## SAMPSON COUNTY 911 & ES FACILITIES

CONSTRUCTION  
DOCUMENTS

### ROOF PLAN

DATE	12.04.2020	
PROJECT NO	20003	
REVISIONS		
NUM.	DATE	DESCRIPTION:
REV1	12/17/20	REVISION 01

ROOF PLAN SCALE: 3/32" = 1'-0"

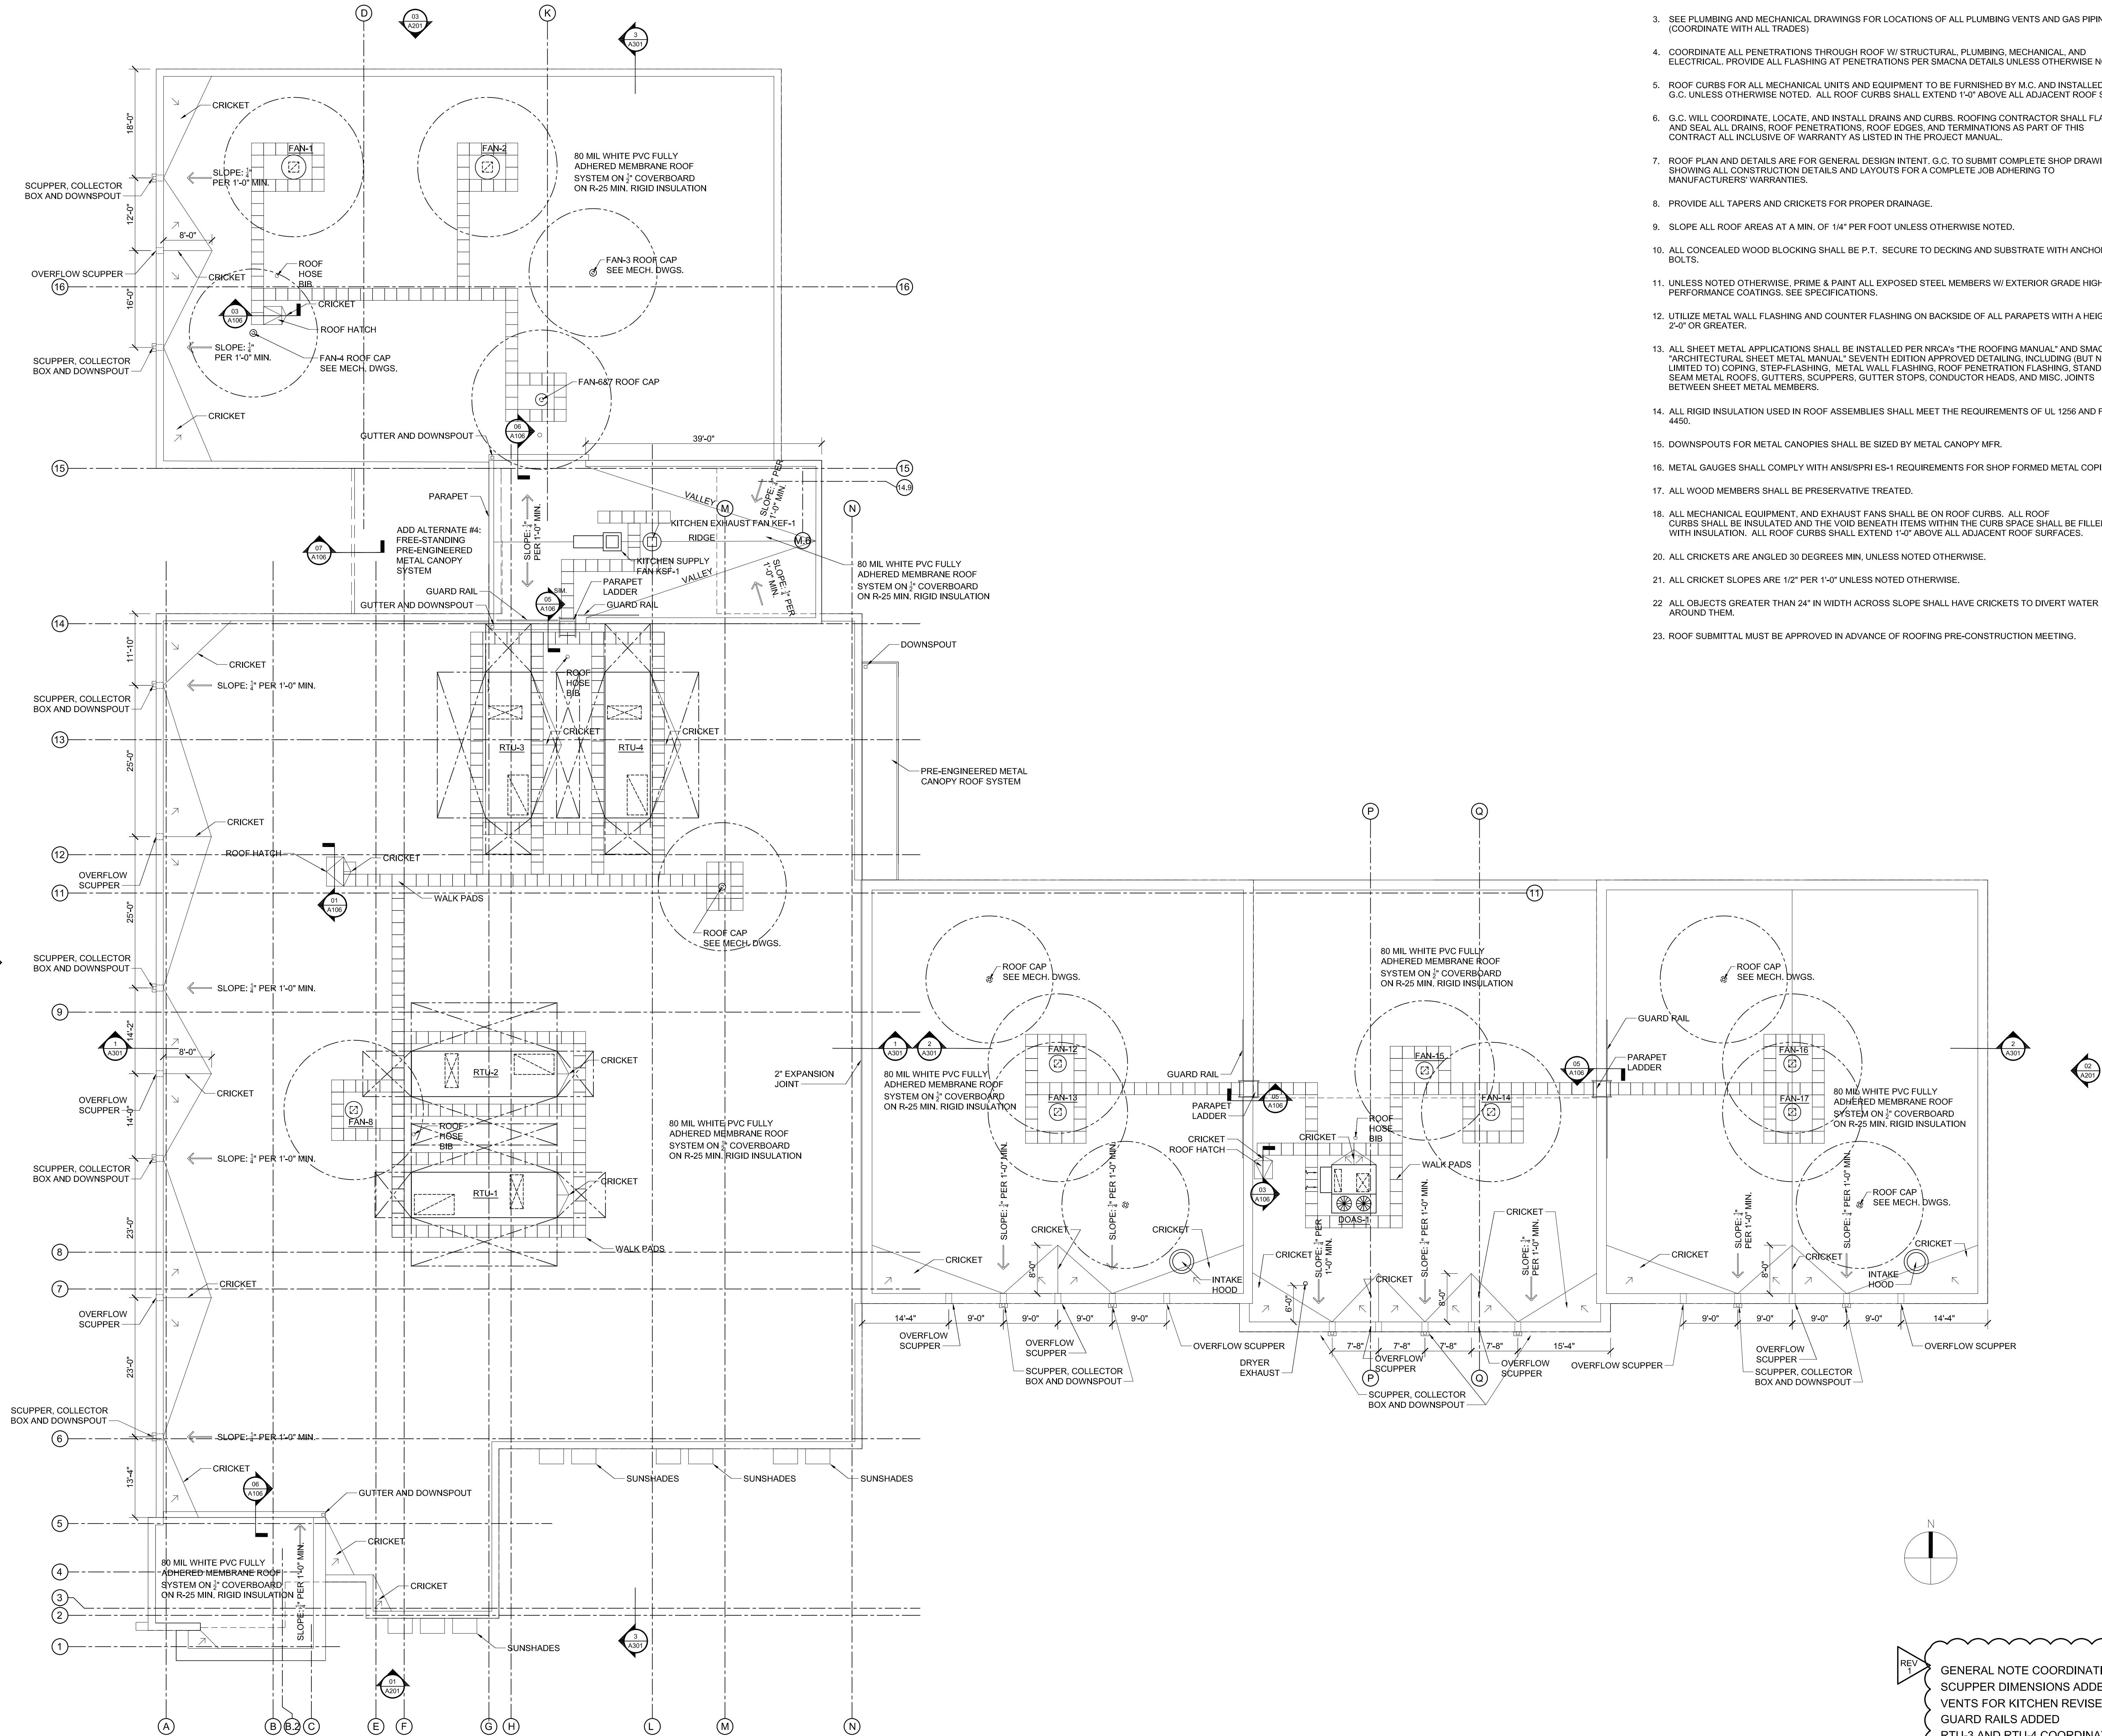
REV GENERAL NOTE COORDINATION  
SCUPPER DIMENSIONS ADDED  
VENTS FOR KITCHEN REVISED  
GUARD RAILS ADDED  
RTU-3 AND RTU-4 COORDINATED
